## N25 Rosslare Europort Access Road

### ROAD SAFETY AUDIT STAGE 1

November 2021

**Title**  
N25 Rosslare Europort Access Road  
Phase 3  
Drainage Layout  
Sheet 01 of 01

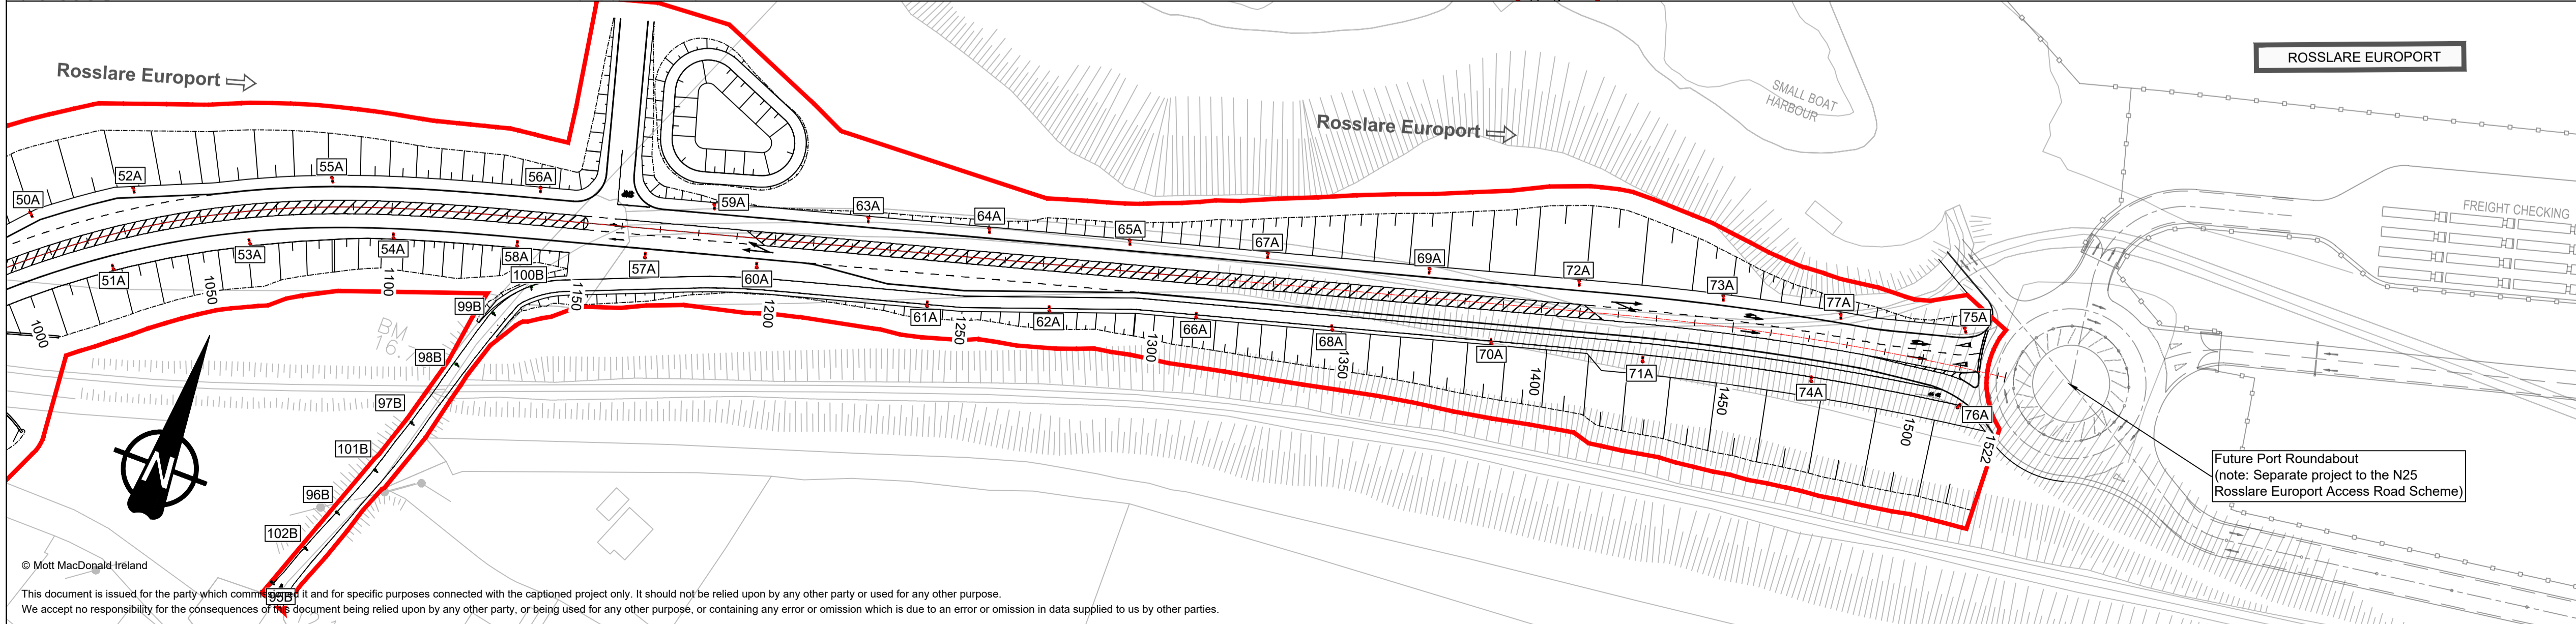
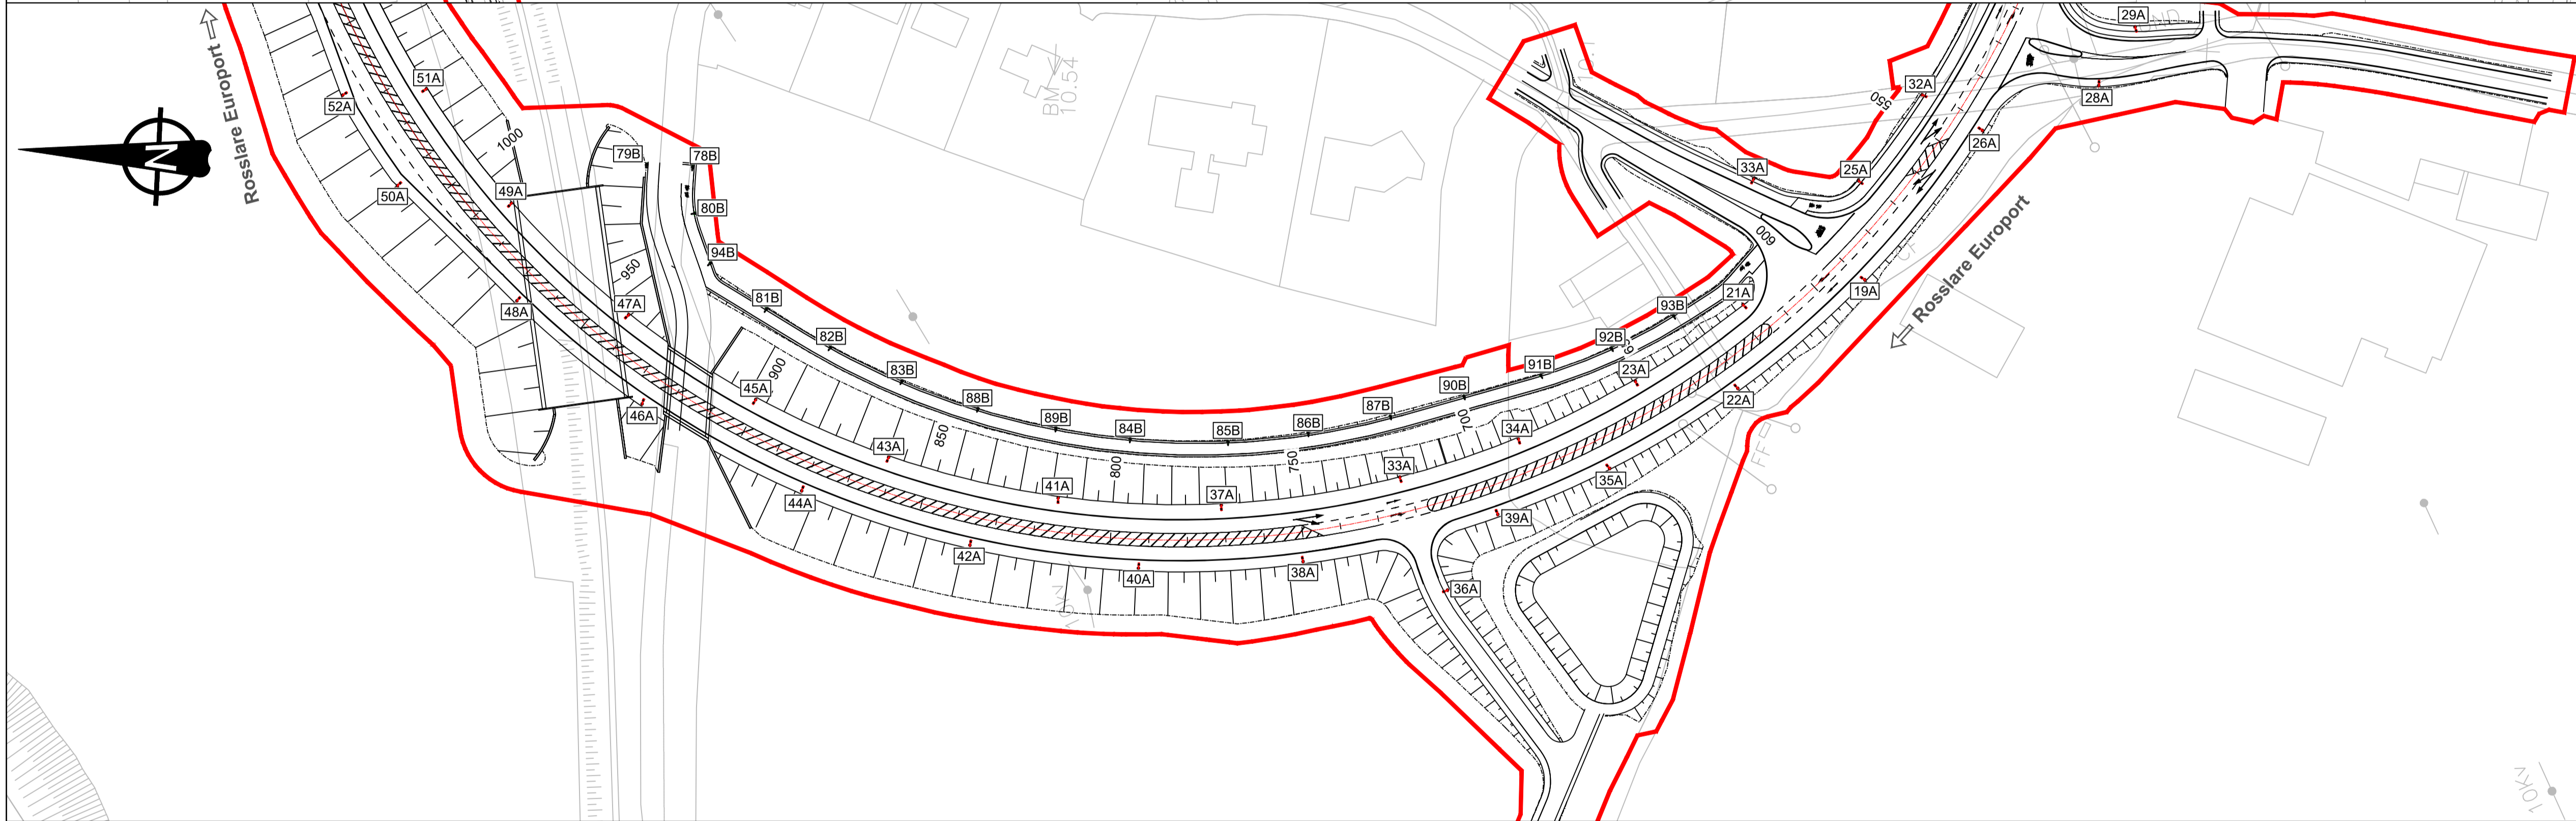
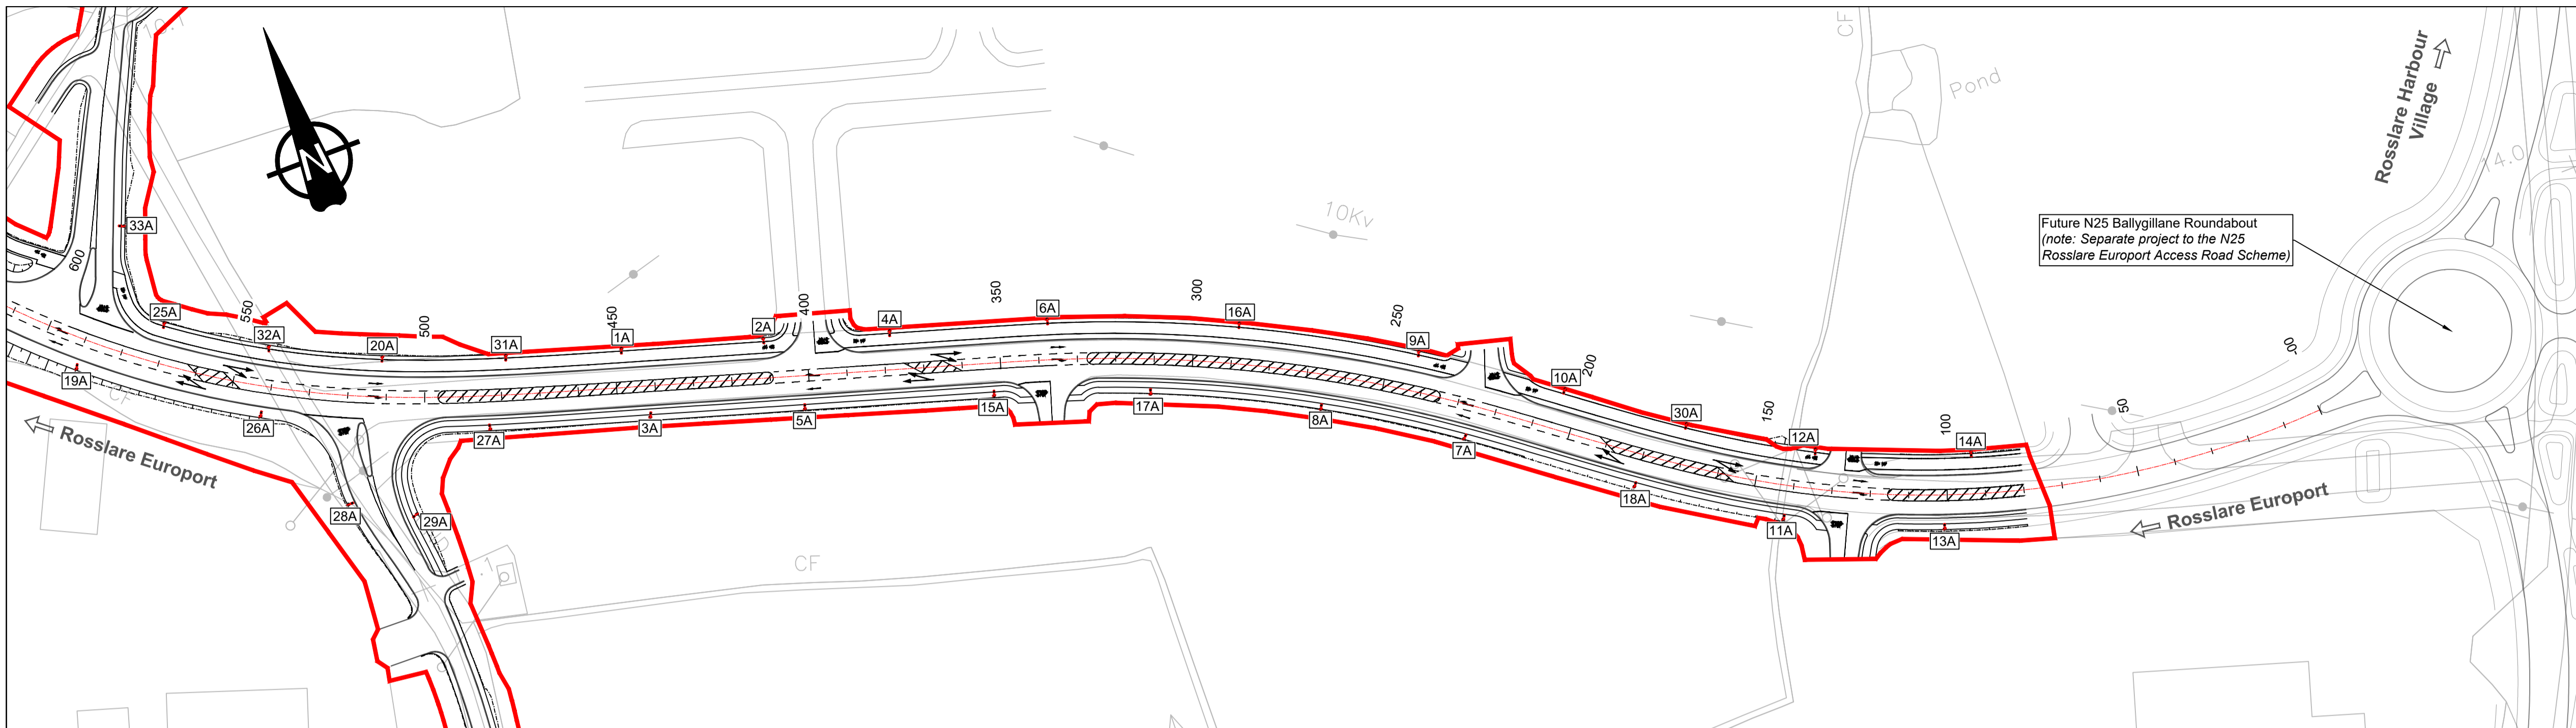
#### 2.7 **Problem: Possible poor drainage of road surface**

The road may be relatively flat in areas where superelevation rollover is coincident with low longitudinal gradient. Inadequate surface drainage could increase the risk of wet-weather collisions. Potential flat areas are:

- between Ch2100 and Ch2300, adjacent to the sag
- Ch490.

**Recommendation**

Check the drainage efficiency of the surface and, if necessary, amend the proposed geometry of the road.

N25 Rosslare Europort Access Road  
Phase 3  
Public Lighting Layout

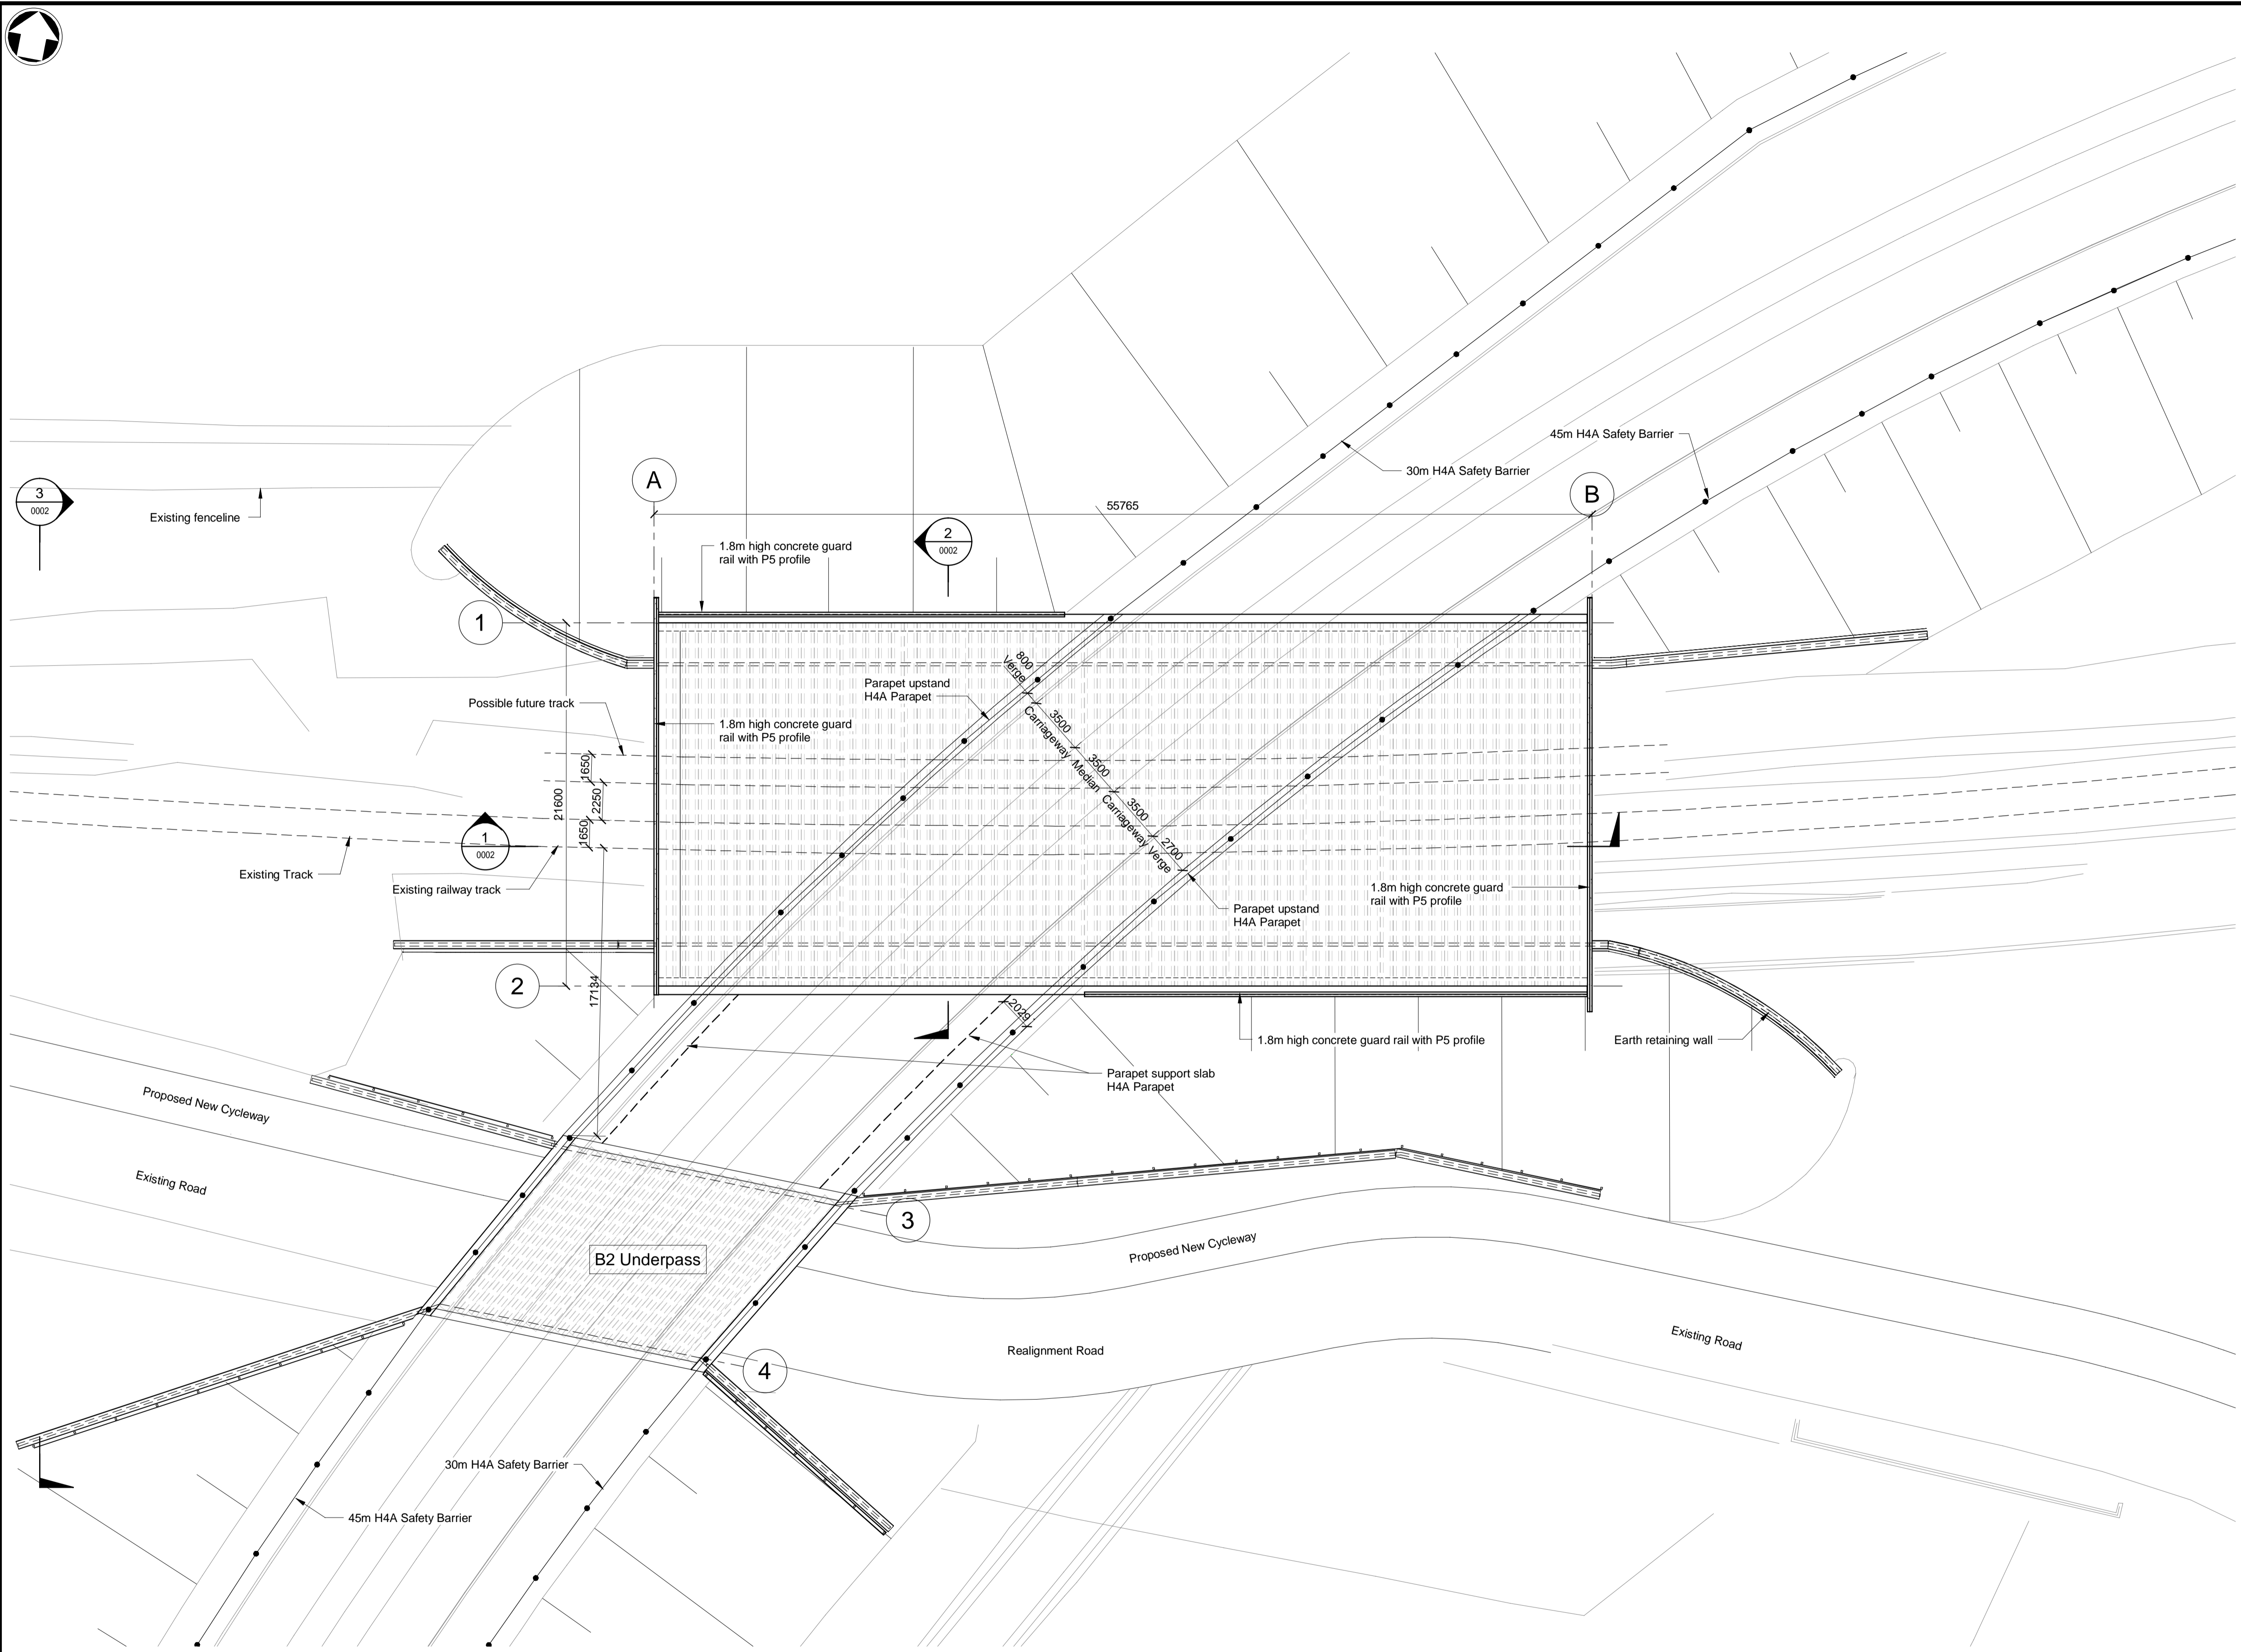
**2.8 Problem: Unlit Cycle Track**

The section of the shared footpath / cycle path that is on the existing Churchtown Road is the only section not to be lit. This may increase the risk of cycle collisions during hours of darkness at that location.

**Recommendation**

Light this section of road too

2.5	Y	Y	-----	-----
2.6	Y	Y	-----	-----
2.7	Y	Y	-----	-----
2.8	Y	N	The section of existing Churchstown Road that the Auditor is referencing to is outside the remit of this project. No infrastructure alterations are proposed to this section of the Churchstown Road and thus it is not intended as the designated cyclist route. The proposed cycle/active travel route to the Port is via the active travel facility along the toe of the road embankment which will connect to the planned Rosslare Harbour to Rosslare Strand Greenway at Chainage 950. Nevertheless, the problem and recommendation highlighted will be forwarded to the Wexford Co Co for their information/consideration.	Yes
